DOCKET NO. 40-9027

LICENSE NO. SMC-1562

LICENSEE: CABOT PERFORMANCE MATERIALS, REVERE,
PA

SUBJECT: SAFETY EVALUATION REPORT, SITE
DECOMMISSIONING PLAN AND RADIOLOGICAL
ASSESSMENT DATED FEBRUARY 28, 2001

Figure 1. Generalized conceptual model used in the Cabot-Revere assessment.

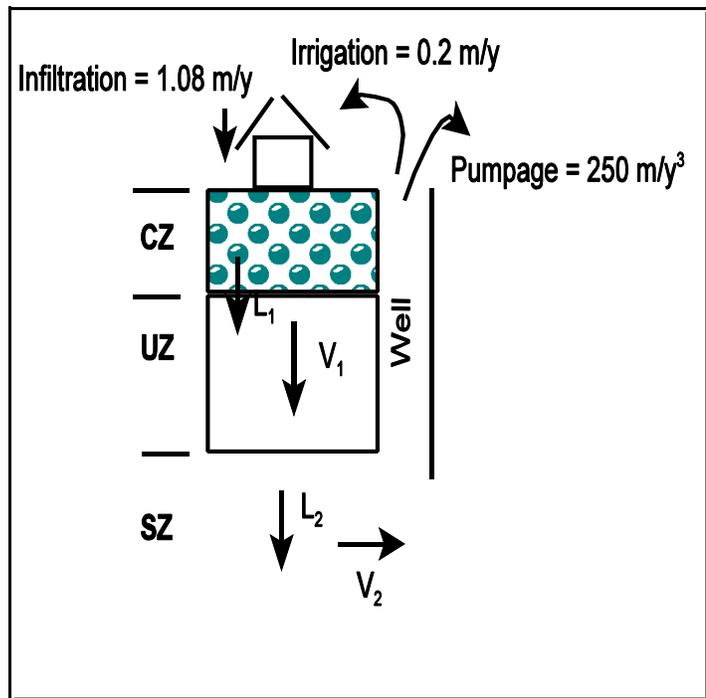
Figure 1 shows a schematic of the general conceptual model used in the Cabot-Revere radiological assessment, based upon staff's interpretation of the information presented in the report.

It should be noted that a default irrigation rate of 0.2 m/y was used in the analysis although the licensee only assumed irrigation as part of their residential gardener scenario.

Based on regional information, the unsaturated zone is believed to be roughly 20 meters thick; however, for the assessment nominal credit is taken for the possible hold-up of contaminants migrating through the unsaturated zone. This is reflected by the small unsaturated zone thickness (0.01 m) assumed for the analysis. Staff believes that this adds conservatism to the calculated doses for the water-dependent pathways.
